Response to Submissions

Werris Creek Coal Mine Modification 2 (PA 10_0059)

Werris Creek Coal Mine – Modification 2

(PA 10_0059)

Figure A Comparison of Air Emission Sources	5
---	---

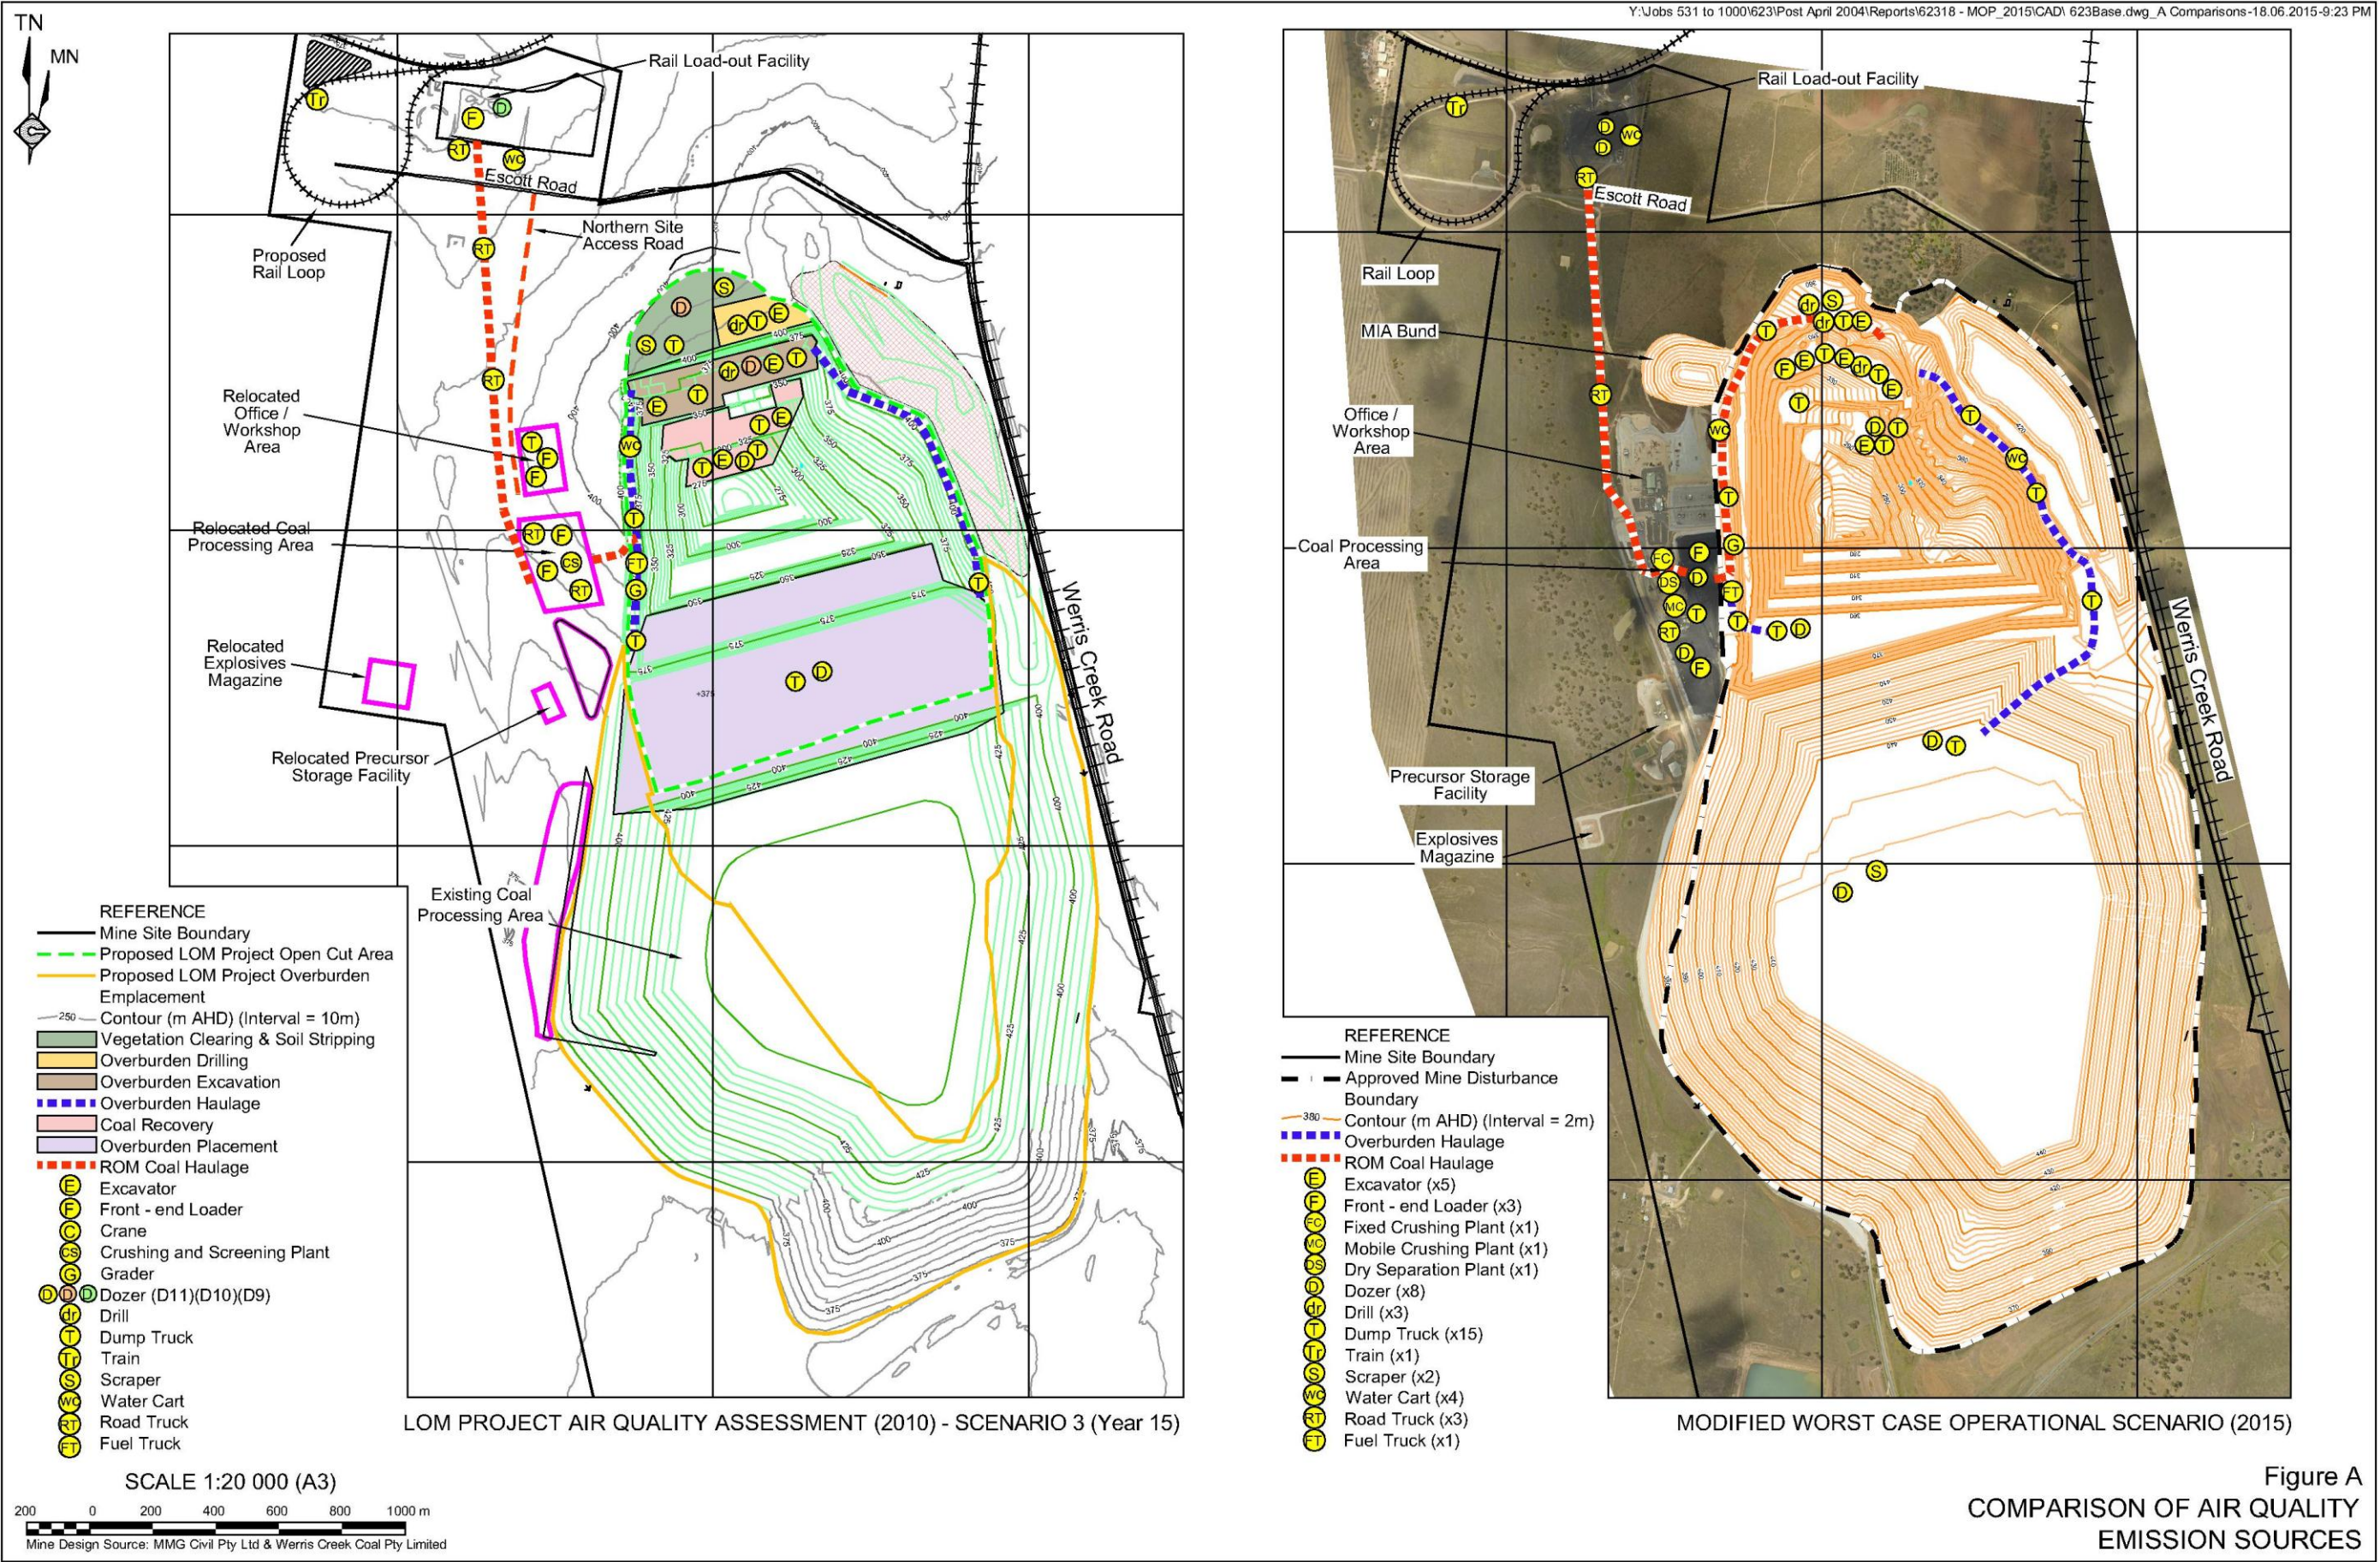
- *The review by SLR Consulting of the 2010 Air Quality Assessment by Heggies Pty Limited has not remodelled air quality impacts at surrounding receptor locations. It has instead relied on a comparison of estimated emissions from the proposal based on current best practice techniques against the three scenarios modelled by Heggies (for Years 3, 7 & 15 of the 2010 Life of Mine Project) as a quasi means of validating this past modelling...*

- *This approach however has not considered the different geographic locations of key emissions sources (e.g. the main overburden dump), nor the location of additional sources (e.g. the proposed additional haul trucks, or the dry separation plant) of the Heggies Year 3 scenario relative to the modification proposal. There is a risk therefore that the Heggies (2010) predictions that SLR assert are representative of impacts at the nearest receptors may be under-predicting impacts.*

- *The EPA therefore recommends that the impacts of the proposed modified operations are assessed by remodelling the site to accurately reflect the proposed operating scenario, to confirm that air quality impacts at the nearest receptor locations comply with the relevant assessment criteria, prior to the approval of the modification.*

A teleconference including Mr Lindsay Fulloon (EPA), Mr Martin Doyle (SLR Consulting - author of the Air Quality Assessment), Mr Andrew Wright (representing the Applicant) and Mr Alex Irwin (RWC) was held on Thursday 21 May 2015 to discuss the EPA's request for remodelling of air emissions.

Prior to and during the teleconference, the EPA was supplied with a copy of the air quality modelling scenarios used in the 2010 Air Quality Assessment for the Mine LOM Project development application (Heggies, 2010). The EPA was referred to the similarity in air emission sources between Scenario 3 of Heggies (2010) (*Figure 18*) and the worst-case scenario of the modified operations (as considered by SLR, 2015). **Figure A** provides the two scenarios side by side for comparison.

- the dispersion modelling of Heggies (2010) has provided an accurate prediction of air emissions (as evidenced by monitoring since 2010);
- the emissions inventory of the modified operation is equivalent to that of Scenario 3 of Heggies (2010); and
- the locations of emission sources are in equivalent positions to those modelled for Scenario 3 of Heggies (2010).

Therefore, on the basis that the emissions modelling of Heggies (2010) has been validated, and the worst-case scenario for the modified operations is equivalent to that modelled by Heggies (2010), the EPA has confirmed that no further air quality modelling is required.
